ADDENDUM #2

Feb 25, 2026

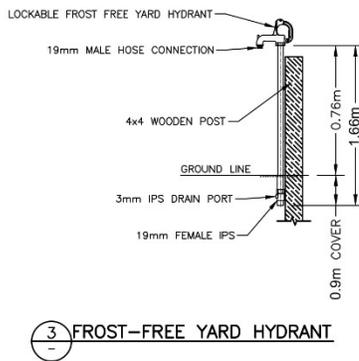
Q18. For the sampling station (Eclipse 88) can you provide a detail and or clarify:

- a. Any Isolation Valves required for the stations
- b. Size of water line? 19mm, 25mm or other?

A18. Instead of Eclipse 88 sampling stations, proponents shall refer to the following detail for the sampling station.

Note that each sampling station shall include the main corporation stop, curb stop assembly, and associated piping included. Waterline size to match detail above.
